## CERTIFICATE OF APPROPRIATENESS

**Property:** 536 Harvard Street, Lot 21, Block 289, Houston Heights Subdivision. The property includes a two-story historic 2,808 square foot four-plex apartment building and a detached garage situated on a 6,600 square foot (50' x 132') interior lot.

**Proposal:** Alteration – Revision, exceeded approved scope of work.

**WEST ELEVATION – FRONT FACING HARVARD STREET**

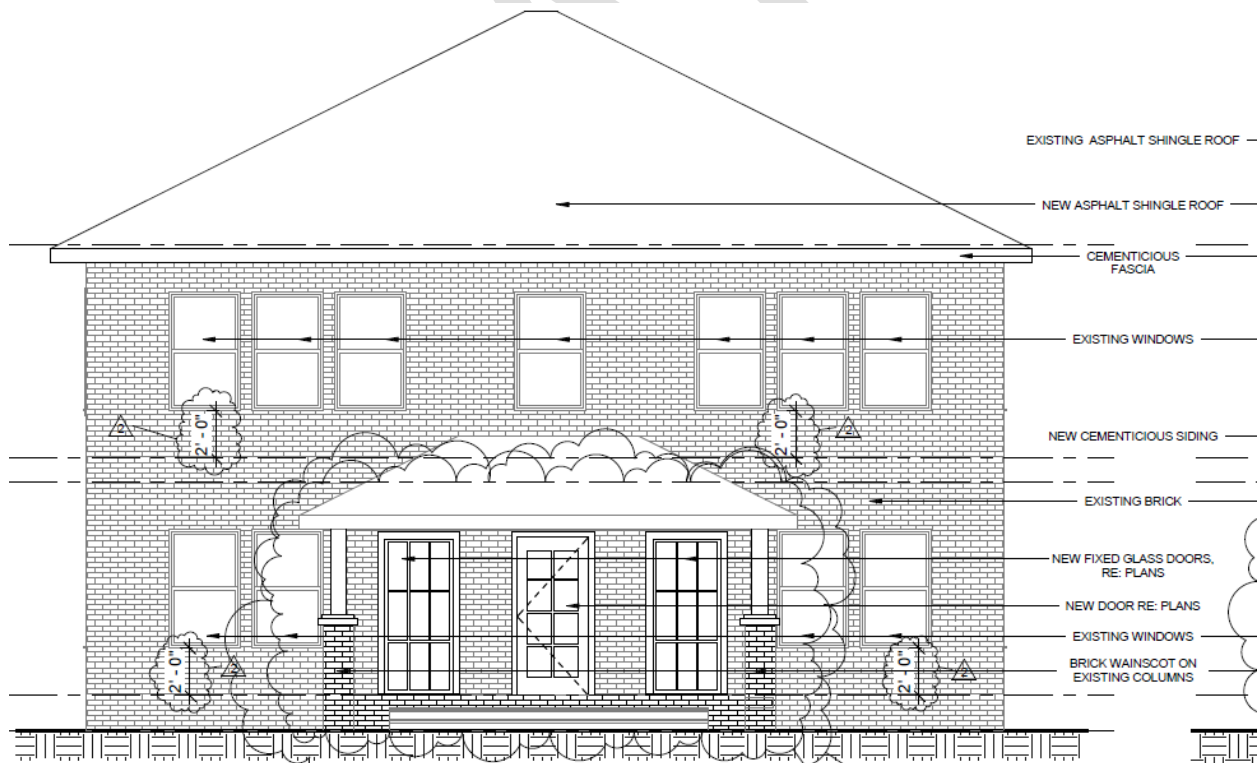
- ☐ ☒ ☐ (1) The proposed activity must retain and preserve the historical character of the property;  
The partial brick encasement of the original full length columns, removal and replacement of the original front door, installation of slate tile on the porch and steps, and the removal of original windows and bricking in window openings does not preserve the historical character of the property.

Staff recommends to the applicant that all of the alterations be reversed. These changes exceeded the permitted scope and are in violation of the approved COA. The original windows that removed in order for the window opening to be bricked in were destroyed. The original front door was also destroyed. The bricked in window openings should be reopened and salvaged windows should be installed. The front door should be replaced with a salvaged door. The brick pier built around the columns should be removed. The slate tile on the porch floor and steps should be removed. Exterior grids should be added to the flanking auxiliary doors.

**NORTH SIDE ELEVATION**

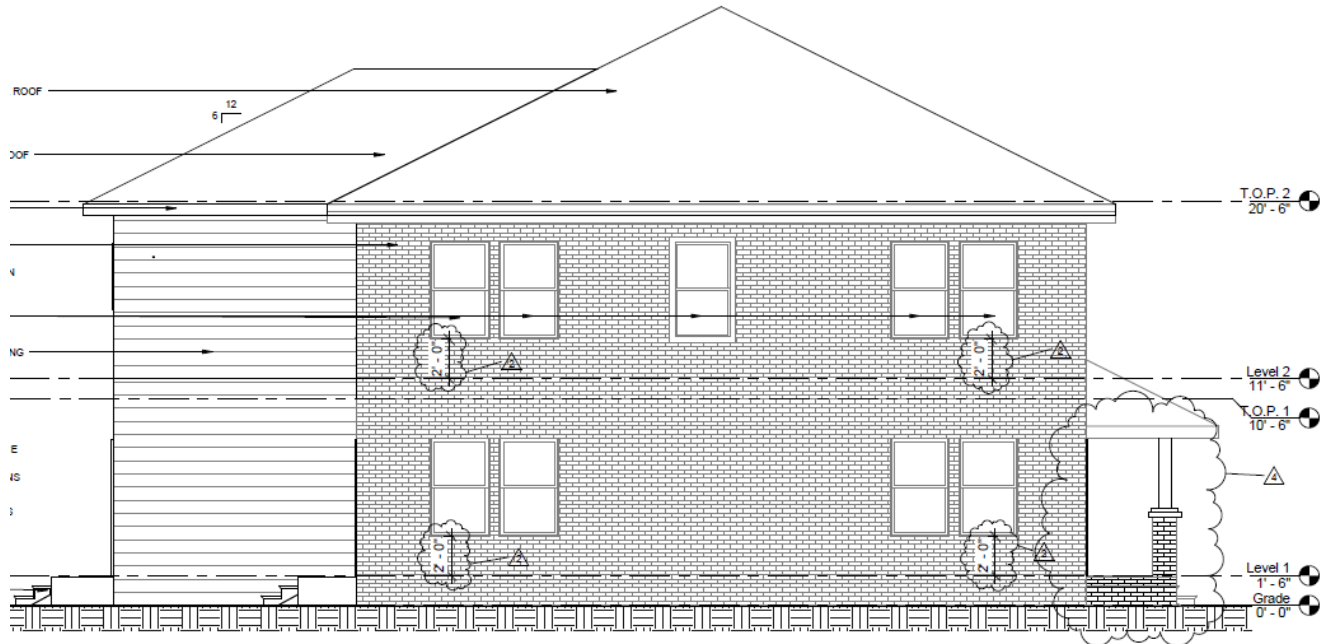
- ☐ ☒ ☐ (8) Proposed additions or alterations must be done in a manner that, if removed in the future, would leave unimpaired the essential form and integrity of the building, structure, object or site;  
Bricking in the original window openings alters the essential form of the building.

**Windows/Doors:** On the north elevation, a pair of windows and a single window on the first story were removed and the openings bricked in. A single window on the second story was also removed and the window bricked in. On the south elevation, a single window on both stories was removed and bricked in. The windows were destroyed. These window alterations do not appear as part of the application and are not indicated on the drawings. The original front door was removed, despite the Commission determination that the original door was to remain. The auxiliary front doors were to feature an exterior grid pattern. The installed windows feature no grid pattern.
